Your Model

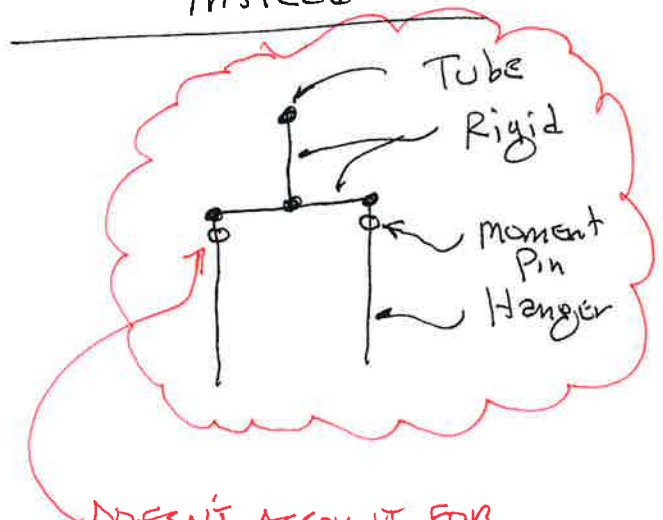
DOESN'T ACCOUNT FOR
ECCENTRICITY OF TOP PLATE.
UNDER GRAVITY, HANGER IS
IN TENSION ONLY

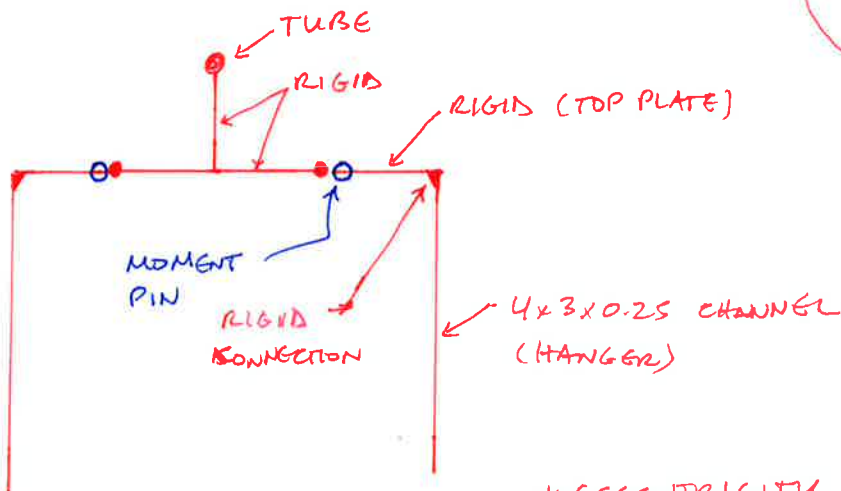
Should it be this instead?

* ECCENTRICITY OF TOP
PLATE PRODUCES MOMENT
IN HANGER UNDER GRAVITY
LOADS
